LR-N17-0088

**Quality Assurance Topical Report, NO-AA-10,
Revision 86**

Summary Of Changes

PSEG NUCLEAR LLC - QUALITY ASSURANCE TOPICAL REPORT
NO-AA-10, REV. 86, REVISION SUMMARY

**Simplified Organizational Relationship Chart
Figure 1-1**

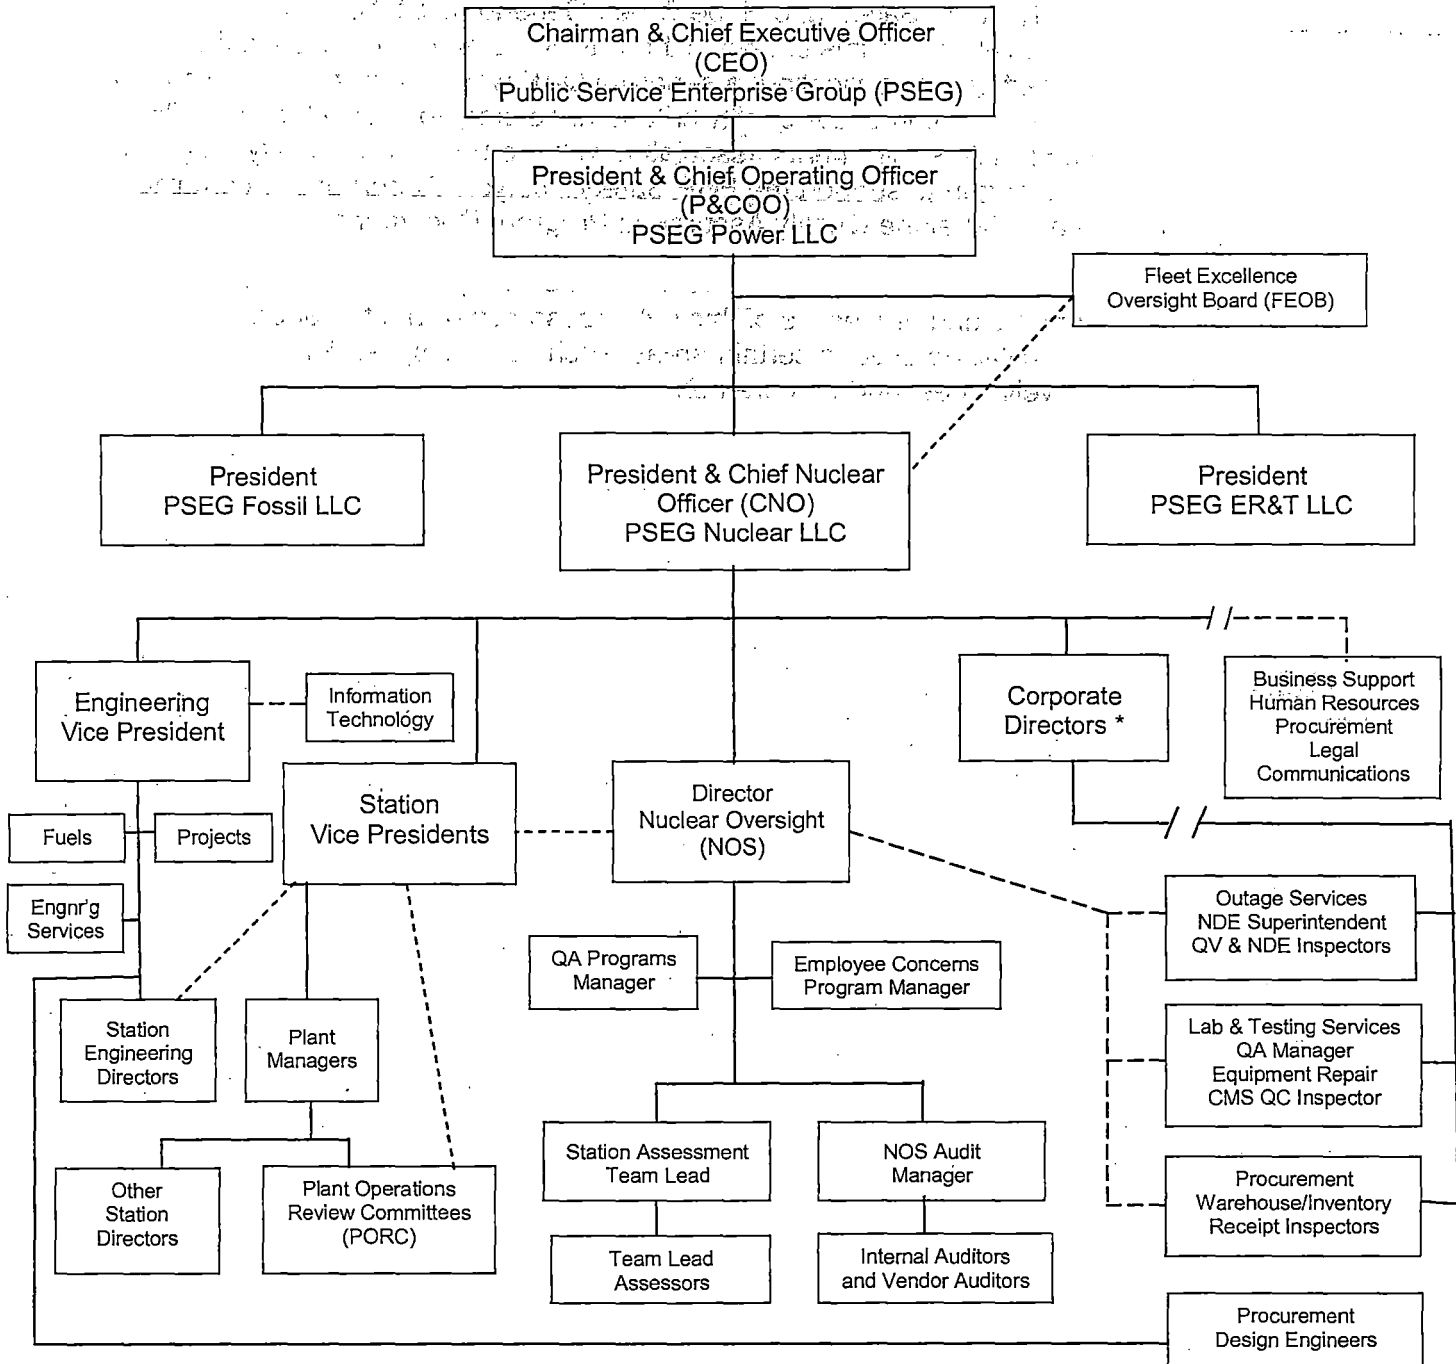
- In section 2.2.3 item 6., changed "Nuclear Safety Review Board" to "Plant Operations Review Committee".
- *In Figure 1-1, the block for the Nuclear Safety Review Board was changed to the Fleet Excellence Oversight Board. Also in this figure, the reporting relationships and titles of certain groups' matrixed to the NOS Director were updated. [Request # 16-50]*
